AGENDA MEMORANDUM

Title: Site Development Plan Approval

Subject Property: 221 N. Wilcox Street

Proposed Mixed-Use Building (retail & 39 condos)
Project # SDP18-0008

Proposed façade from Wilcox Street
(looking northwest)

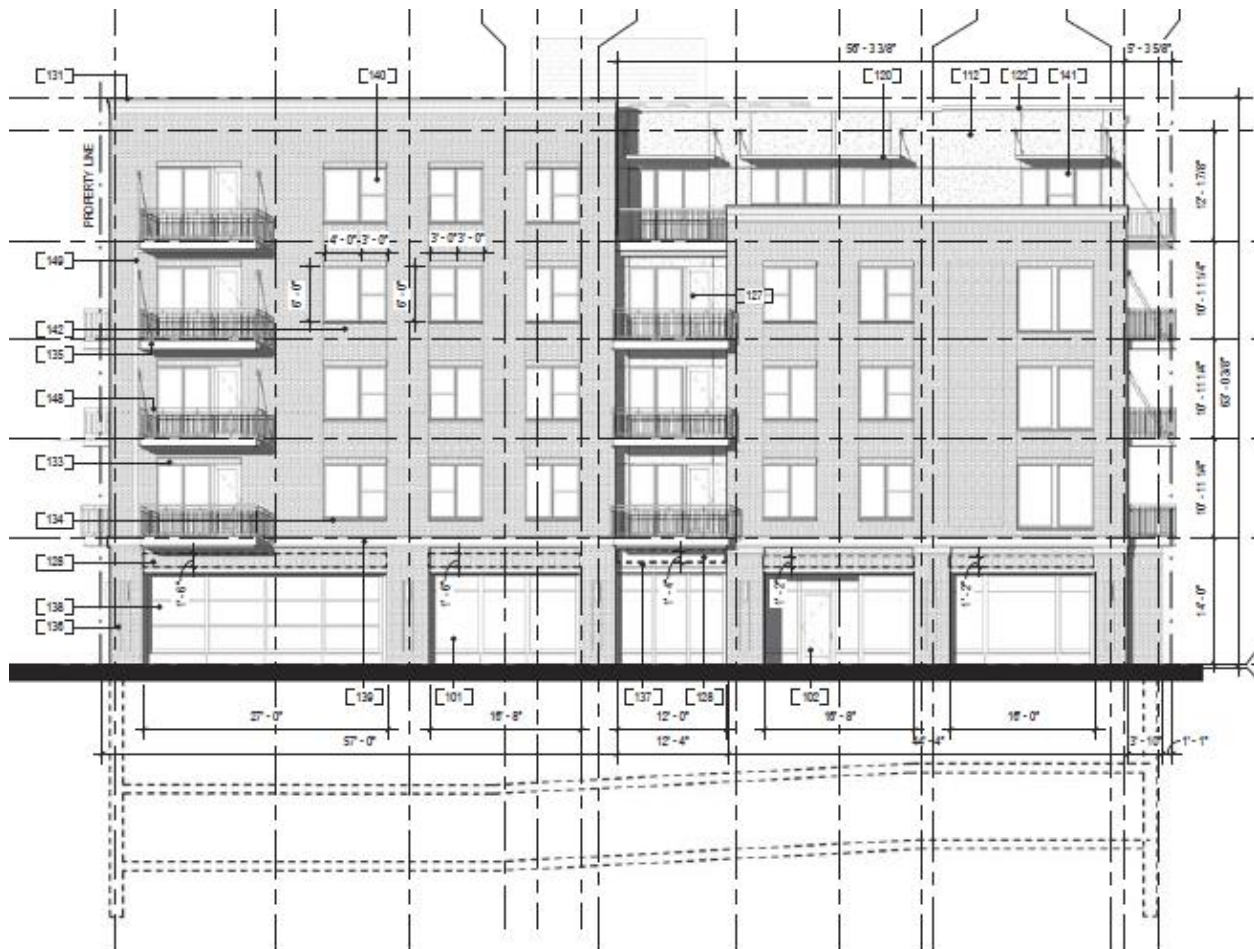
Staff Comment –

The crown design facing the public streets includes beige stucco walls, masonry brick, metal entry canopies over upper story windows, and precast coping and black metal coping at the parapet.

Proposed Third Street Elevation
(underground parking levels shown with dashes)

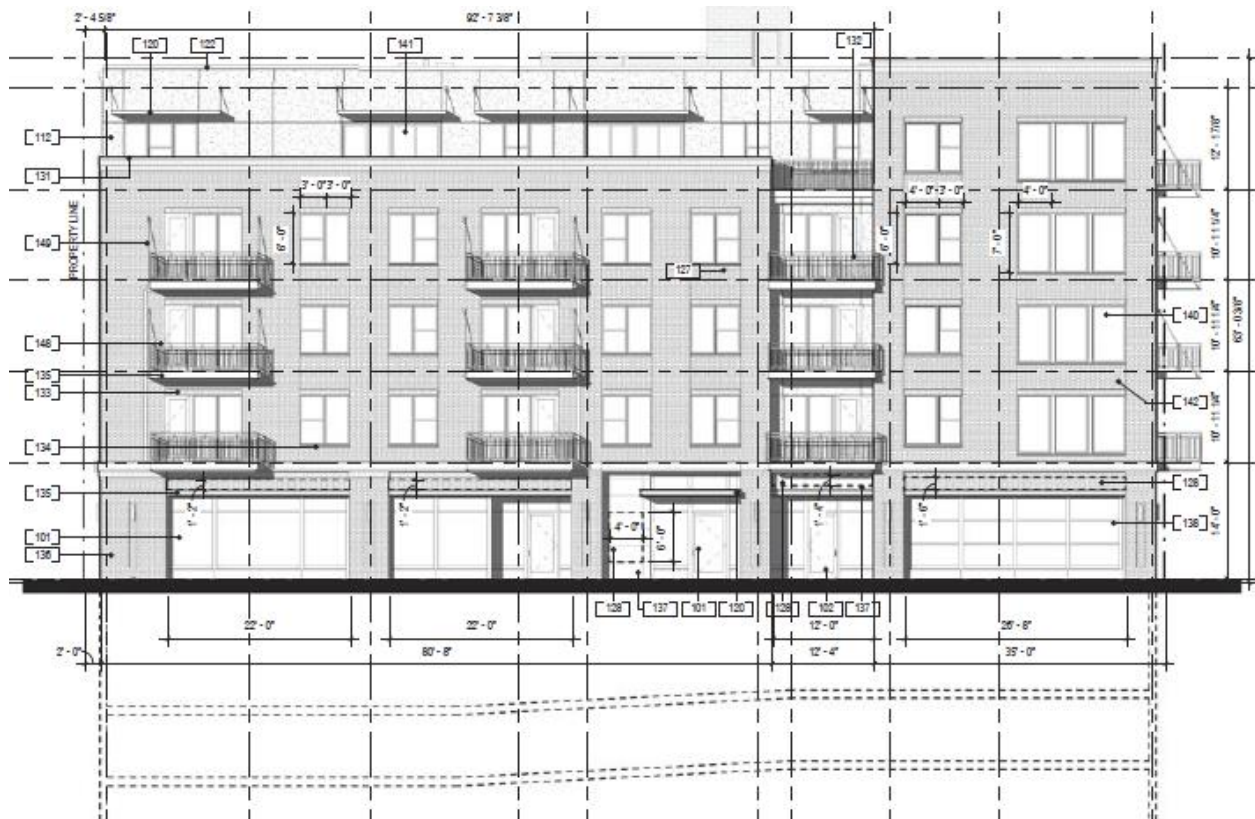
Staff Comment – The façade along Third Street (north façade) totals approximately 118 feet. Windows and/or glass doors account for approximately

88 feet of this façade, which provides approximately 75% transparency. The façade facing N. Wilcox Street (east façade) is about 136 feet long with windows and/or glass doors accounting for at least 83 feet of the facade, or approximately 61% transparency.

Proposed street view from Third & Wilcox intersection
(looking southwest)

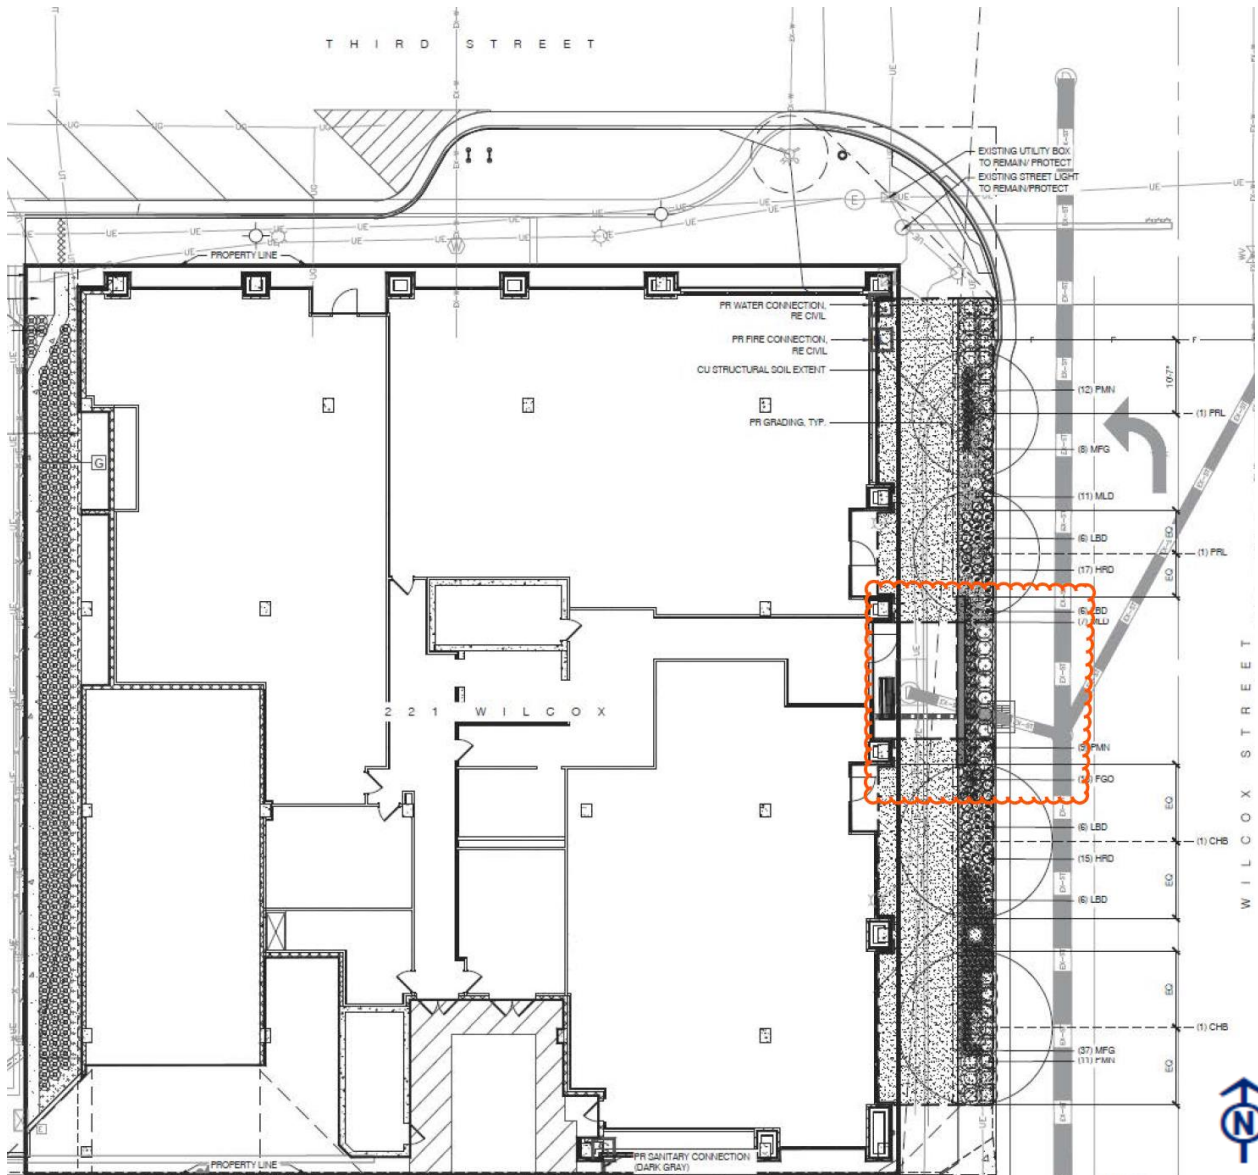
Staff Comment – The applicant is requesting an additional story and associated height (Attachment B). By incorporating brick and stucco façade material, similar to the Riverwalk North building that received approval for an additional story, the building uses elements of nearby historically landmarked properties. Specifically, the landmarked building at 302 N Wilcox Street was originally faced with stucco and many buildings in the 300 block of Wilcox are brick facades. The proposed building height is 62 feet, five inches. While an approval of an additional story also includes the associated increase in height, the proposed height is just under three feet above 60 foot height limit allowed for four-story buildings within the Downtown Core District.

The Mercantile Commons building, which is adjacent to this project on the project's west side, measures 55 feet tall while the Riverwalk North building to the south of this project will be 59 feet tall. The proposed building height of 62 feet, 5 inches would not impact adjacent properties when 60 feet is the allowable height by right.
